Access Compliance Report

Public Rights-of-Way

(Curb Ramps)

Intersection ID: 14998	Main Street: DUNN_AV	Cross Street: GENE_AV	Location: NE
ADA ID: CE5AF14406FF	Ramp Type: Para	Initial Pass/Fail: Fail	Overall Compliance: No
Codes/Mitigation Info/Possible Solution		Field Measurements/Component Compliance	
Severity Score: 13.75

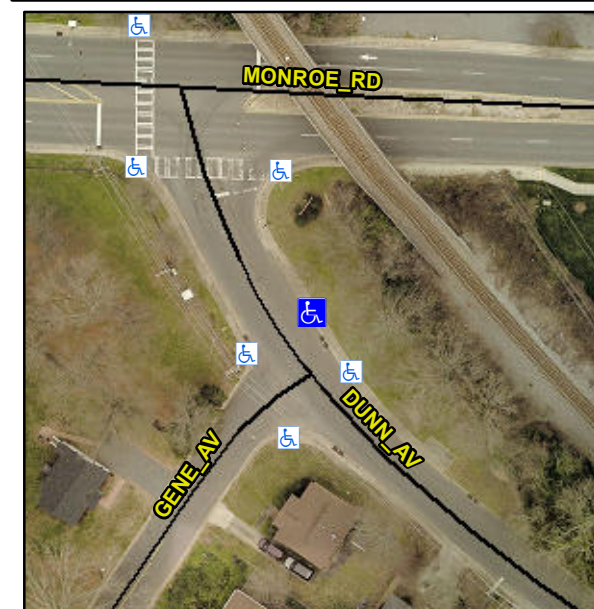
LT RP < 5%

R304.3.2, R304.5.3

Compliance	Description	Data	Compliance	Description	Data
N/A	Ramp Length LT (in)	71.0	N/A	Ramp Length RT (in)	71.0
Yes	Ramp Width LT (in)	59.0	Yes	Ramp Width RT (in)	59.0
Yes	Ramp Slope LT (%)	0.5	No	Ramp Slope RT (%)	10.4
Yes	Ramp XSlope LT (%)	2.0	No	Ramp XSlope RT (%)	3.9
N/A	Landing Length (in)	N/A	N/A	DWS Provided?	N/A
N/A	Landing Width (in)	N/A	N/A	DWS Contrast?	N/A
N/A	Landing Slope (%)	N/A	N/A	DWS Length (in)	N/A
N/A	Landing X Slope (%)	N/A	N/A	DWS Full Width?	N/A
N/A	Landing Curb? (Y/N)	N/A	N/A	DWS Offset (in)	N/A
N/A	Shared Landing?	N/A			
N/A	Gutter Ponding?	N/A	N/A	Gutter Slope (%)	N/A
N/A	Gutter Lip Ht (in)	2.0	N/A	Gutter X Slope (%)	N/A
N/A	Painted X Walk1?	No	N/A	Painted X Walk2?	N/A
	X Walk 1 Direction	To SW		X Walk 2 Direction	N/A
N/A	X Walk 1 Width (in)	N/A	N/A	X Walk 2 Width (in)	N/A
	X Walk 1 Slope (%)	2.0		X Walk 2 Slope (%)	N/A
	X Walk 1 X Slope (%)	6.0		X Walk 2 X Slope (%)	N/A
N/A	Ramp inside XWalk1?	N/A	N/A	Ramp inside XWalk2?	N/A

Remove & Replace Entire Ramp.
